Subject: Scrivanich PUD Public Comment Response, File No. SUB15-02157

Project Description: Proposal to aggregate five parcels and subdivide them into 27 single family lots in the RS 8.5 Use Zone utilizing the Planned Unit Development (PUD) Zoning Code provisions. The project also involves a wetland buffer modification through enhancement.

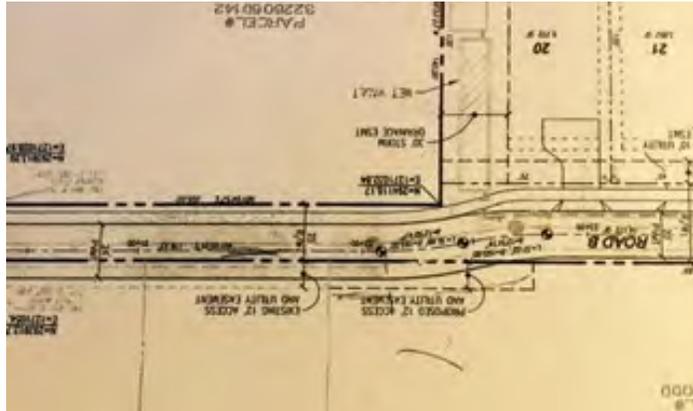
We are writing to note our objection to that portion of the above referenced permit that appears to remove part of our driveway, a tree in front of our house and a large portion, about 1/3rd, of our front yard. We don't understand the full process and we don't object to the large project as a whole, but it would appear that the section that comes in from 112th vs 116th would unnecessarily grossly alter our property. Hopefully there are other ways to accomplish the builders' objective without permanently removing 1/3rd of our front yard.

See photo below of the front of our recently purchased home and that portion of the proposed plan that shows a road cutting through our front yard via a "proposed" easement. We are that property where the wording says "proposed" easement and the road curves through a portion of our front yard. **Our address is 11416 NE 112th Street also known as "Lot C" and parcel #322605-9153-03.** As you can see the front of our house has a two car wide driveway and a one car garage. We need the driveway that is now just over 31 feet long and there is no detail as to what will happen to our front yard.
